**Hamburg Township
Zoning Board of Appeals
Hamburg Township Board Room
Wednesday, March 11, 2020**

Zoning Board of Appeals Staff Report

SUBJECT: ZBA 20-002

SITE: Vacant on Rush Lake Road (west of 3267 Rush Lake Road)
TID: TID 15-17-302-093

Figure 1 - GPS-Surveyed Wetland Boundaries

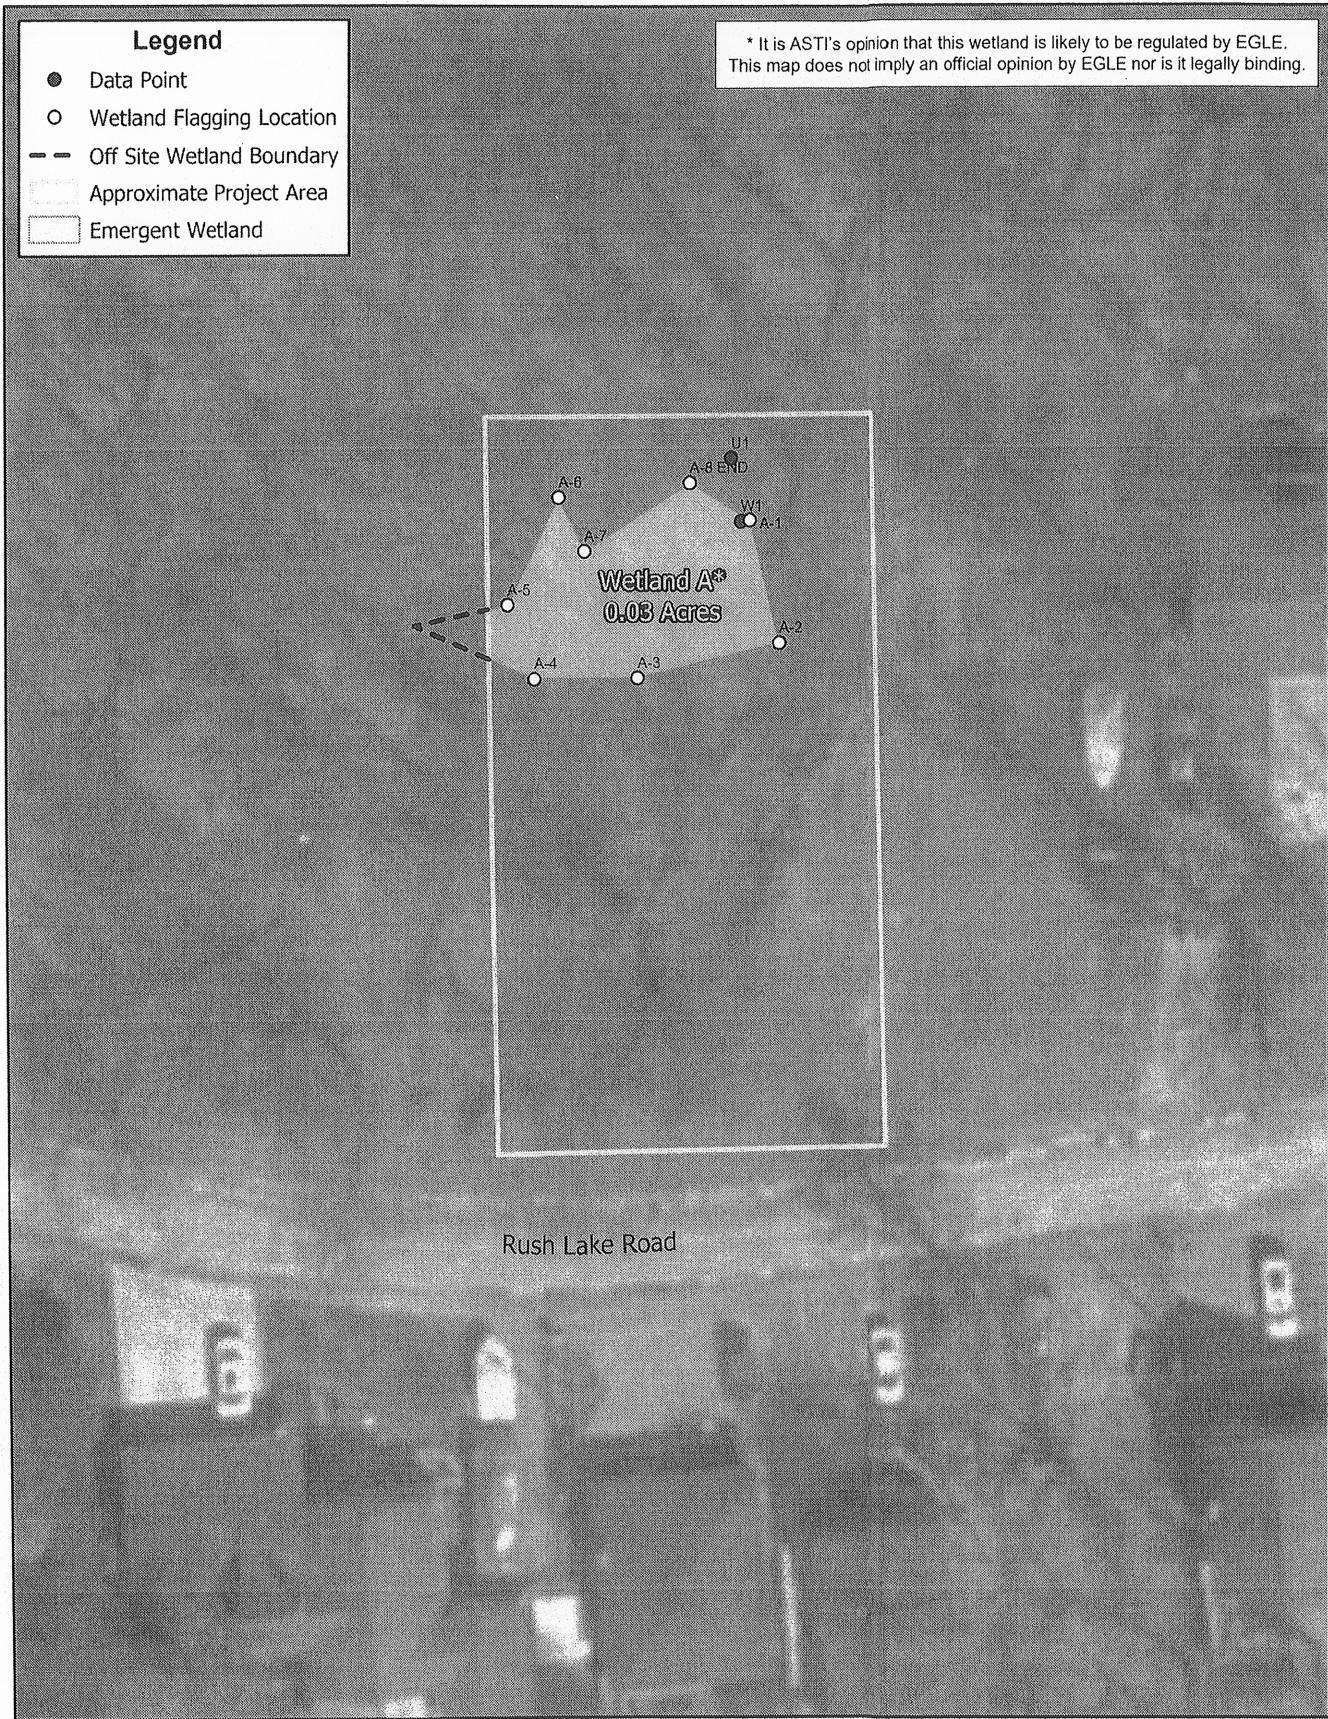
I do not have any concerns regarding the wetland delineation for the site. However, the plan for the proposed house does not include a grading plan. While the proposed house will technically be outside of the wetland, will they be proposing to fill the wetland to achieve grade for the foundation? I would recommend having them provide a grading plan.

Exhibit D

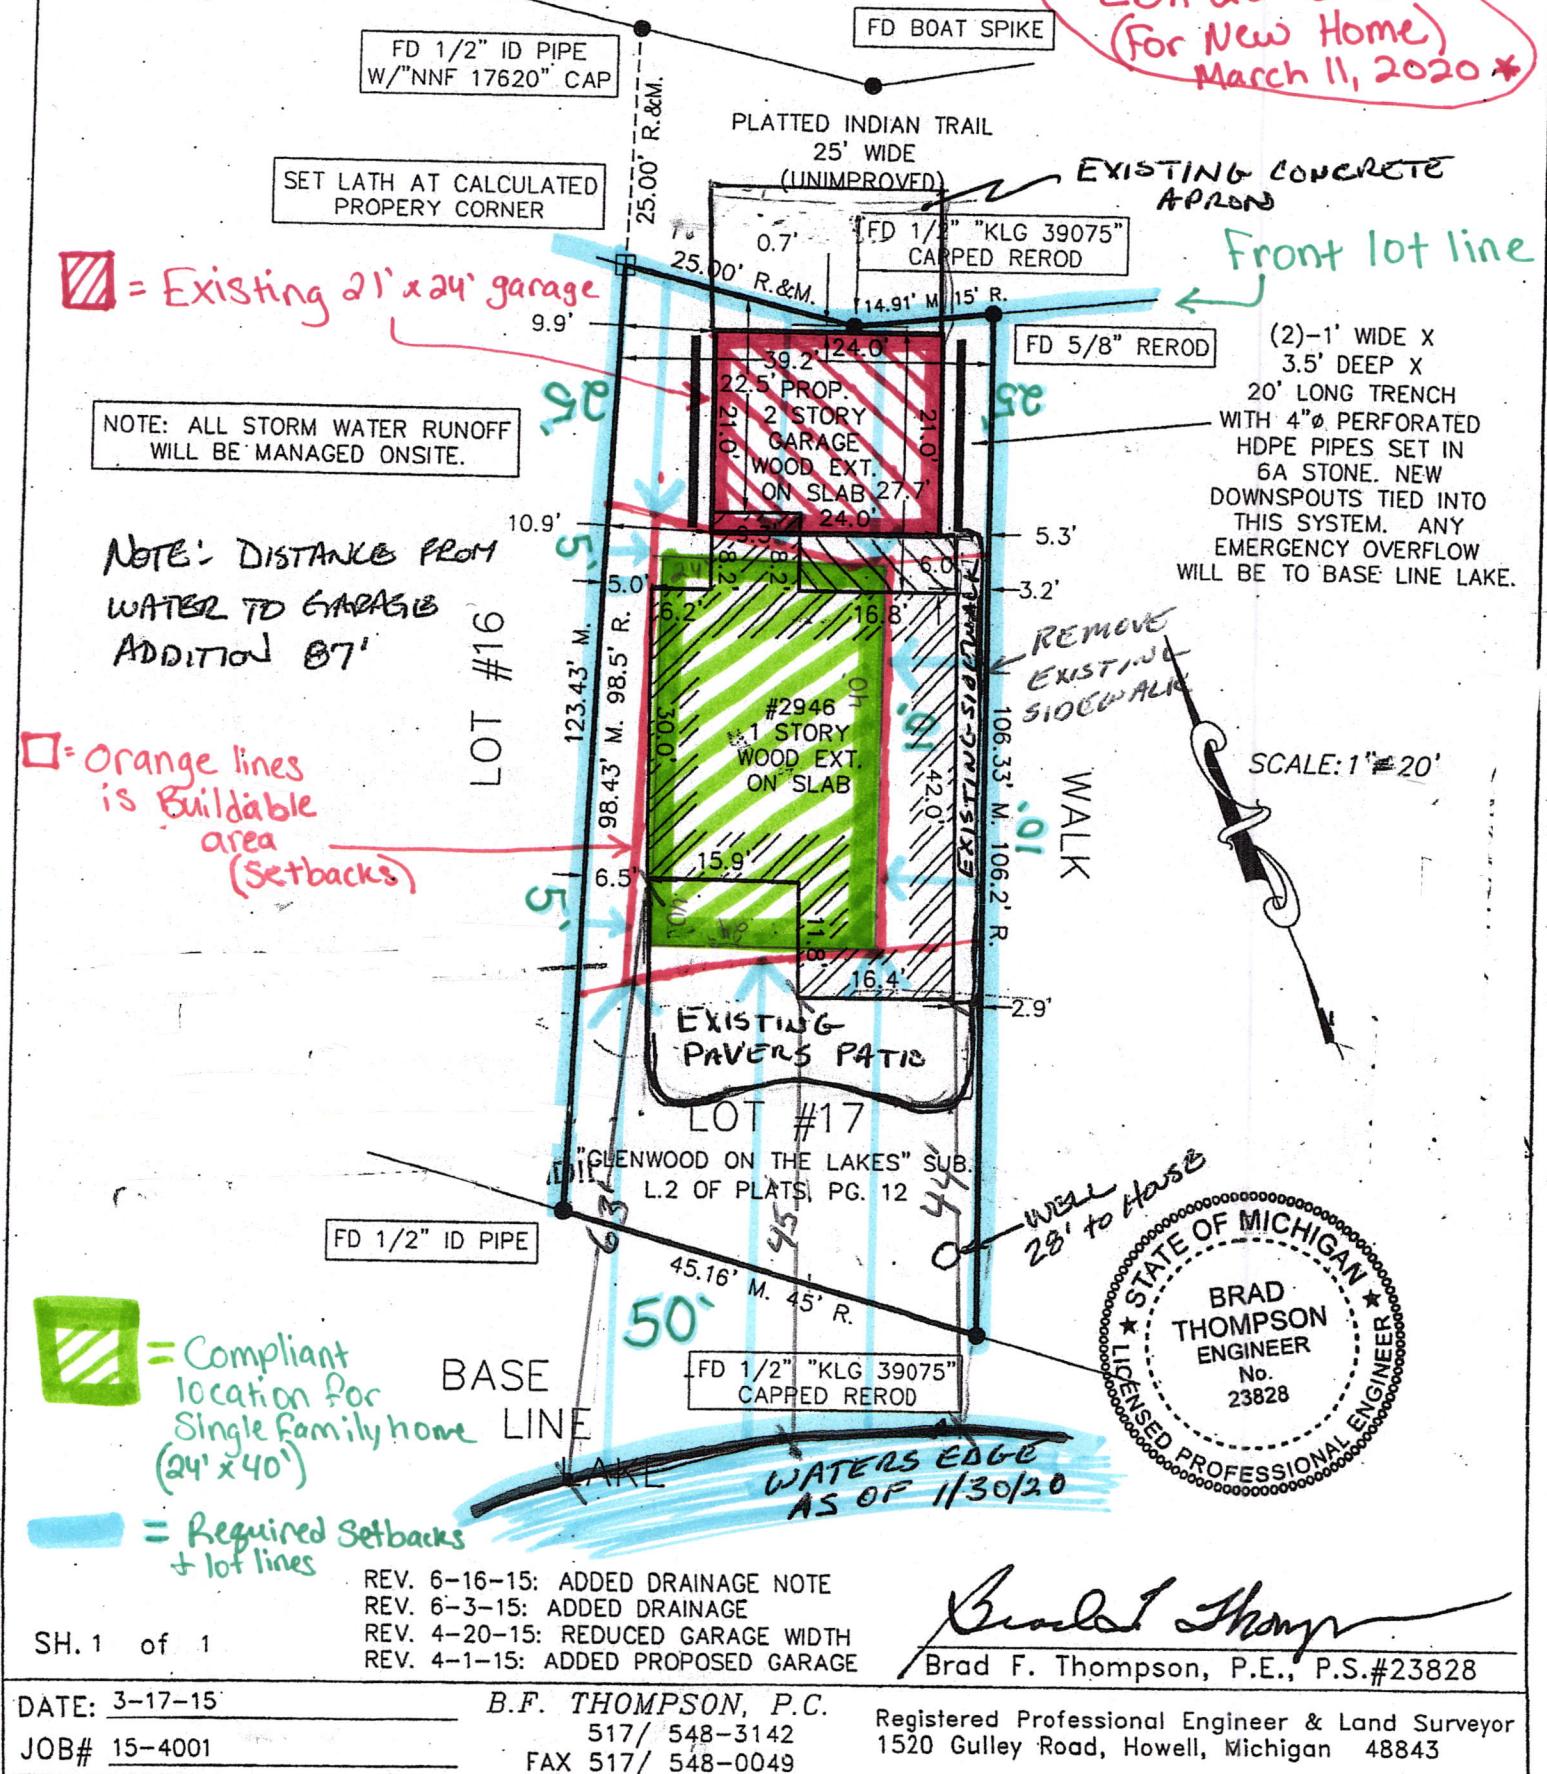
This subject site is a 4,300 square foot lot that abuts the water, requiring a 50-foot setback from the Ordinary High Water Mark of Base Line Lake, where the proposed house will be 44 feet from the water. Additionally, all WFR zoned properties require the primary structure to have a 25-foot front yard setback. Both setback requirements are intended to provide adequate space, open vistas, and privacy throughout neighborhoods and between structures on smaller residential lots. The required front yard setback is 25 feet, the current house is setback 27.7 feet. The proposed house would be setback from the front property line at 21.7 feet and attached to the garage.
